WELL LOCATION AND ACREAGE DEDICATION PLAT

## PECOS DISTRICT DRILLING CONDITIONS OF APPROVAL

<b>OPERATOR'S NAME:</b>	<b>APACHE CORPORATION</b>
<b>LEASE NO.:</b>	<b>NMNM0039880</b>
<b>WELL NAME &amp; NO.:</b>	<b>GHOST RIDER 22 15 FEDERAL COM 31H</b>
<b>SURFACE HOLE FOOTAGE:</b>	<b>2272'S &amp; 540'E</b>
<b>BOTTOM HOLE FOOTAGE:</b>	<b>50'S &amp; 743'E</b>
<b>LOCATION:</b>	<b>Section 15, T.24 S., R.32 E., NMP</b>
<b>COUNTY:</b>	<b>Lea County, New Mexico</b>

# Application Data Report

### APACHE BOP AND CHOKE MANIFOLD SCHEMATIC

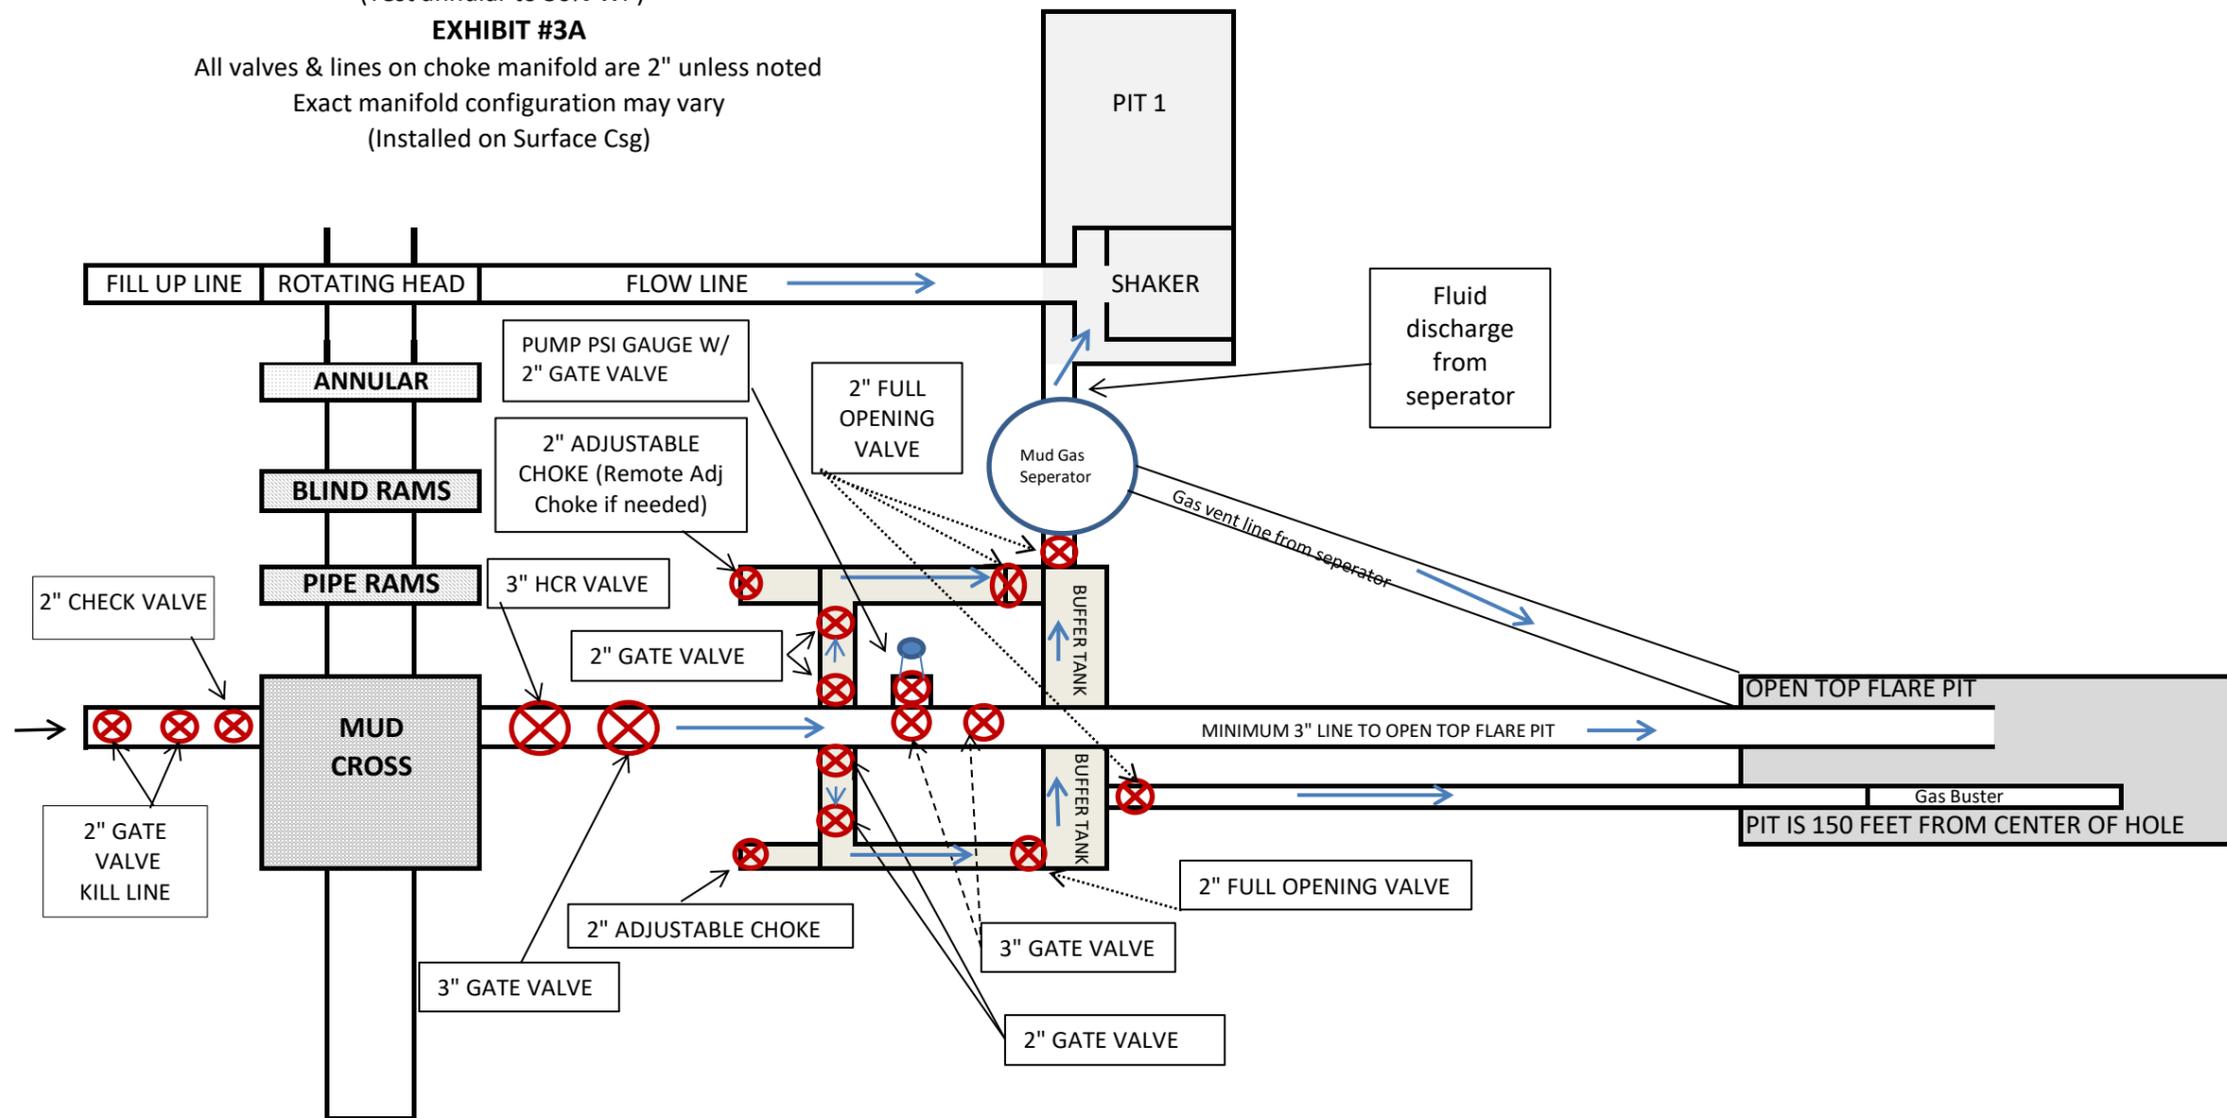
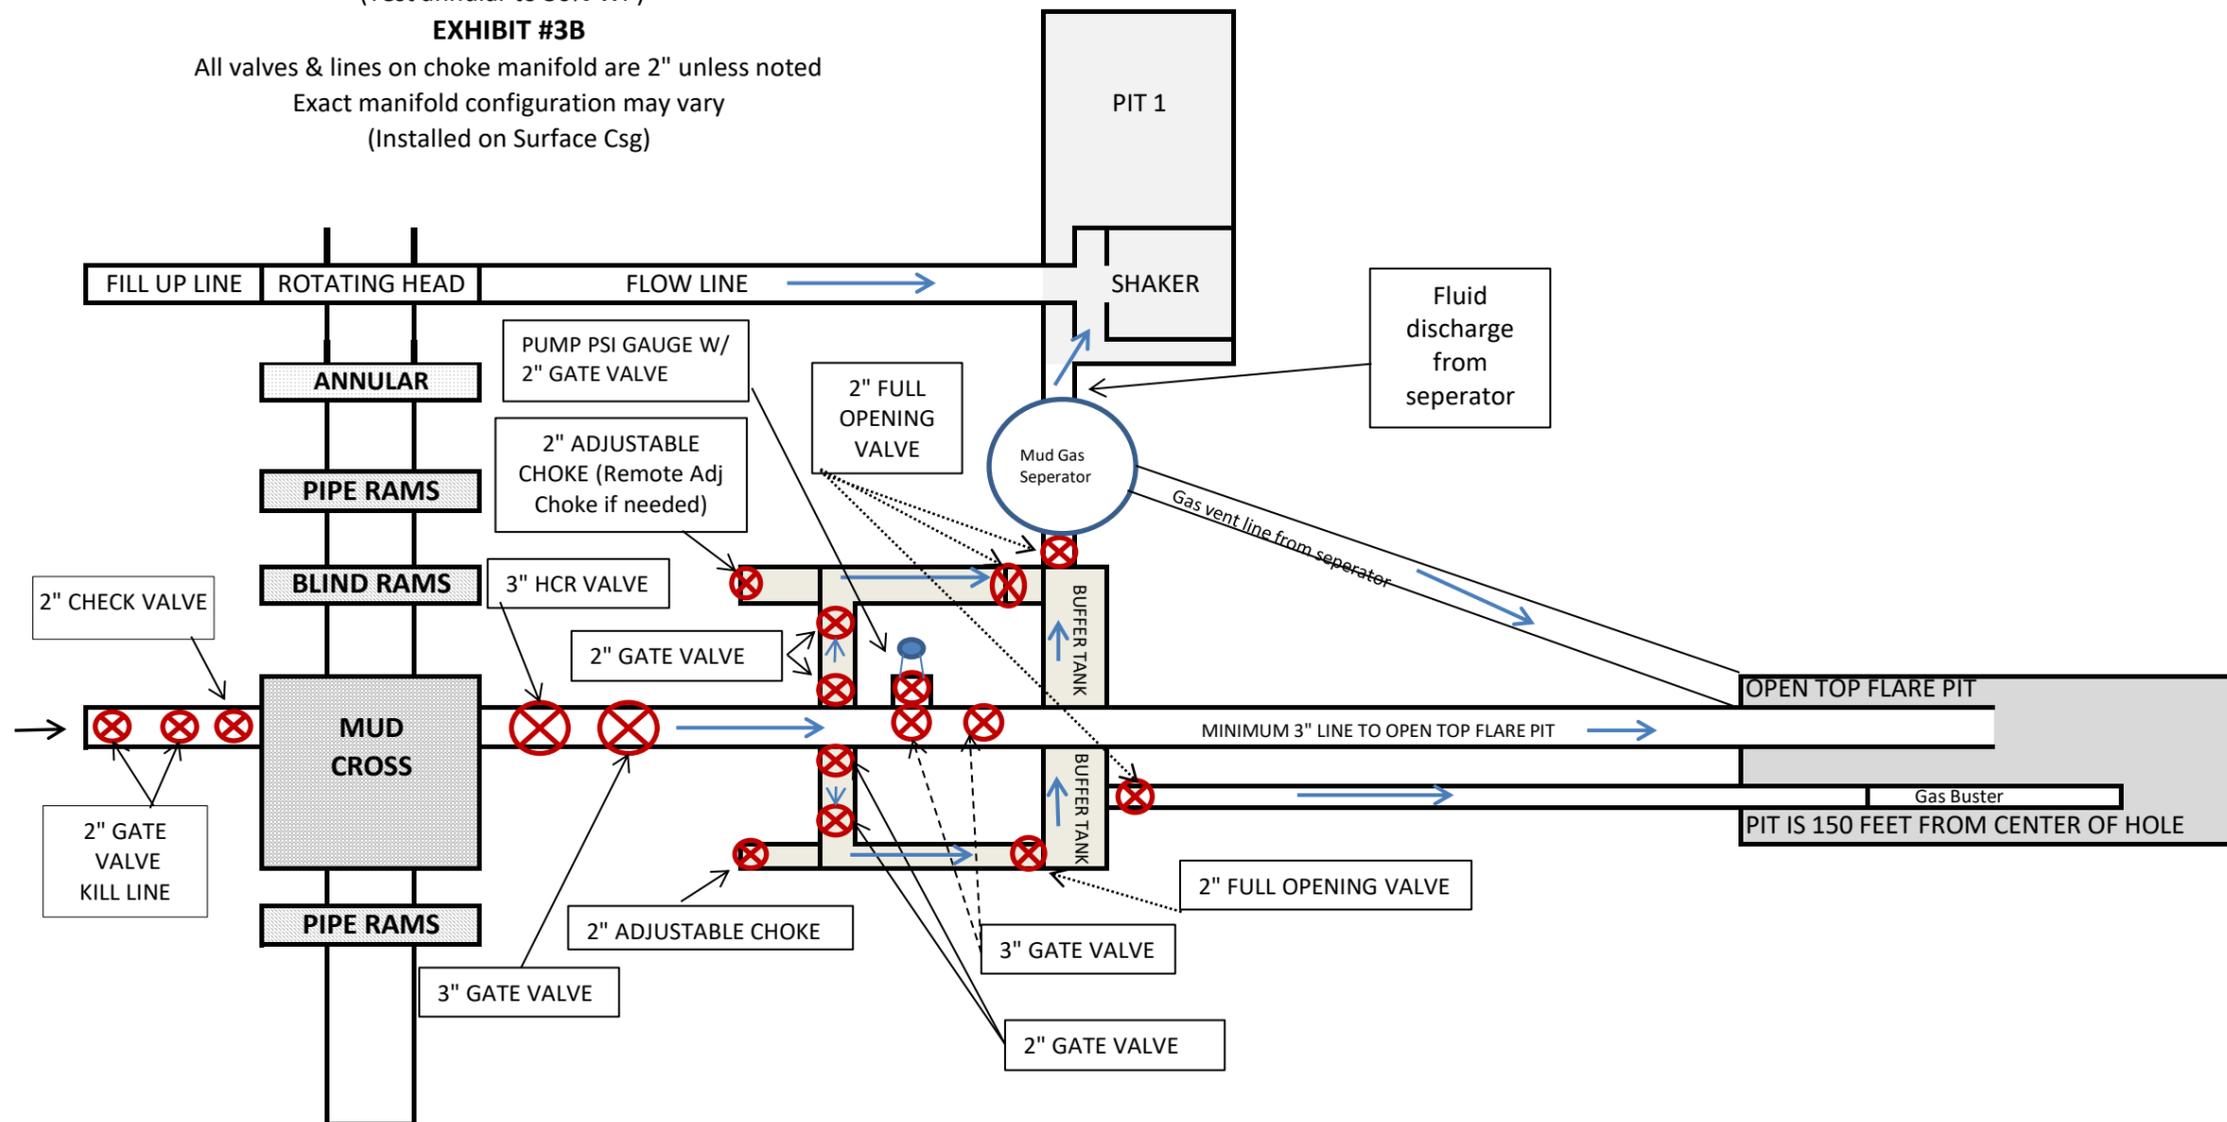
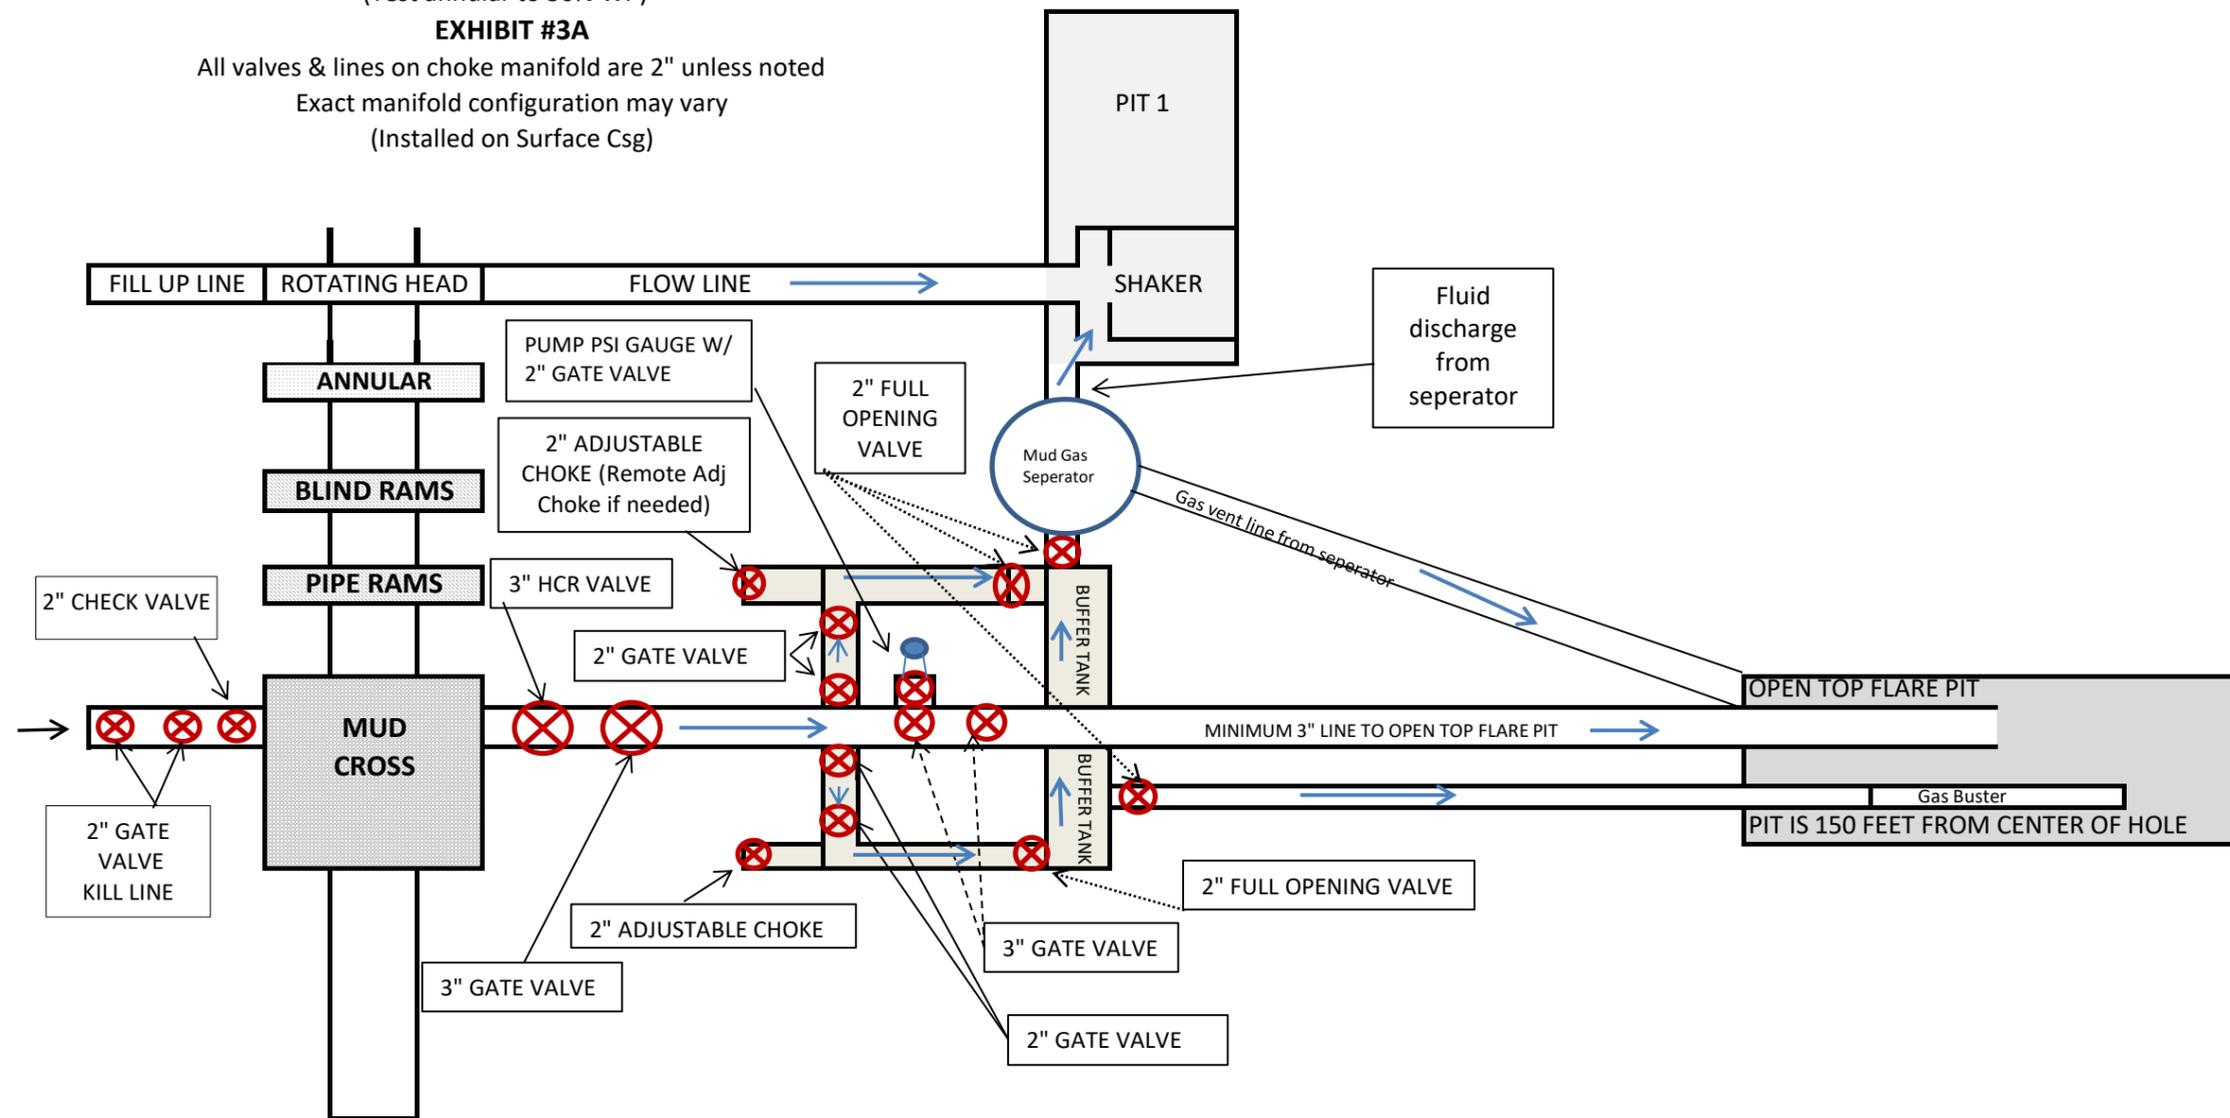
1. Variance approved to use flex line from BOP to choke manifold. Manufacturer's specification to be readily available. No external damage to flex line. Flex line to be installed as straight as possible (no hard bends).'
- 2.

- a. Minimum working pressure of the blowout preventer (BOP) and related equipment (BOPE) required for drilling below the surface casing shoe shall be **2000 (2M)** psi.
- b. Minimum working pressure of the blowout preventer (BOP) and related equipment (BOPE) required for drilling below the intermediate casing shoe shall be **3000 (3M)** psi.

1. Operator has proposed a multi-bowl wellhead assembly. This assembly will only be tested when installed on the surface casing. Minimum working pressure of the blowout preventer (BOP) and related equipment (BOPE) required for drilling below the surface casing shoe shall be **3000 (3M)** psi.
